*Proceedings of the Madras Government, Public Works Department,
4th April 1876.*

No. 70. Read the following letter from Lieutenant-Colonel R. F. OAKES, R.E.,
Superintending Engineer, Tanjore, to Major-General G. W. W. KER,
R.E., Secretary to Government, Public Works Department, dated Tanjore,
22nd March 1876, No. 481:—

(a) *Heads of Service.*—
Fund.—
Class.—Repairs.
Main-head.—Miscellaneous Public Improvement.
Sub-head.—Aids to Marine Navigation, Harbours.
Name of Work.—Repairing Jetty at Negapatam.
Amount.—Rupees 600.
To be carried out by the Public Works Department.

abcd ROUGH STONES AND SANDY SHOAL IT NOW
efg DO AS IT IS TO
ef 3ft
eg 21"

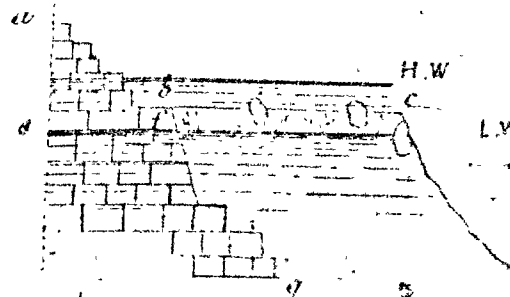
6. The shoal in front of the jetty, and which extends for a length of 125 yards
north of the landing place and which is 7 yards broad and is above tidal L.W., will very
soon disappear if the rough stones which

crop up in it are removed, and if, as the
sand is washed away and other stones are
exposed, these also are removed to L.W.
level at the foot of the jetty, and so as to
form a natural slope from the 3 feet margin
as *ef*, all the stone collected from *abcdg*
should be stacked on shore, and, should the
action of the floods at any time reduce the
stone below the level *ef*, stone should at
once be put in so as to maintain the rough
stone facing as at *efg*. The rough stone
cannot be allowed to fall below L.W.
mark, because the cut-stone facing of the

jetty extends only about a foot below low tide level, and it is not desirable that there should be any direct action on the jetty below this level.

7. If care is taken to collect the stones as they become exposed in the shoal bed, a considerable quantity of stone will be secured; it would be well to keep this to maintain the rough stone facing *e f g*, as it may sink and require renewal from time to time, hence it is proposed to use only 200 cubic feet for the foot of the extended groyne.

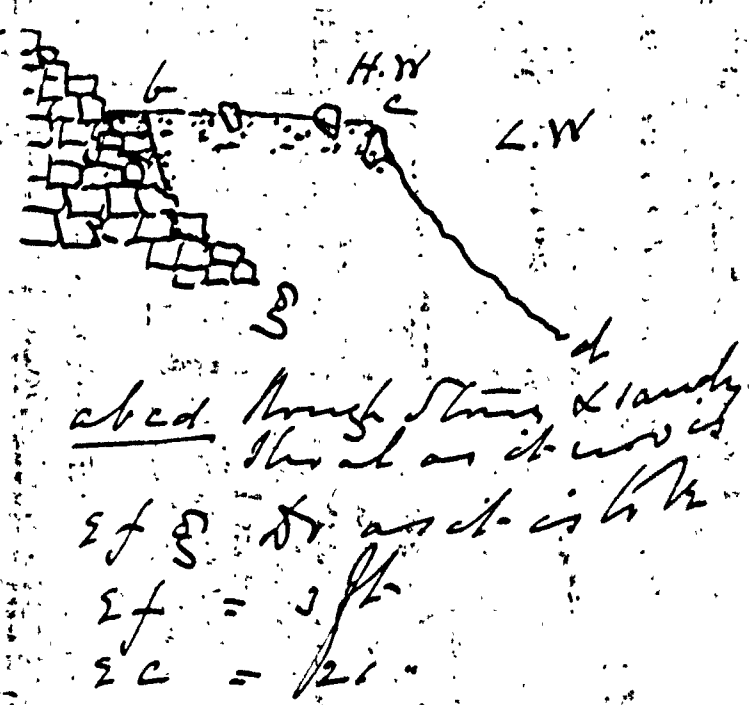
The shoal in front of the Setty
and which extends for a length of 125
yards North of the landing place
and which is 7 yards broad and is,
above

above tidal L.W. will very soon disappear if the rough stones which crop up in it are removed and if as the sand is washed away and other stones are exposed these also are removed to L.W. level at the foot of the Jetty and so as to form a natural slope from the 3 feet margin

as if all the stone collected from abcast should be stacked on shore and should the action of the floods at any time reduce the stone below the level of stone should at once be put in so as to maintain the rough stone facing as at ef the rough stone cannot be allowed to fall below L.W. mark because the cut stone facing of the Jetty extends only about a foot below low tide level and it is not desirable that there should be any direct action
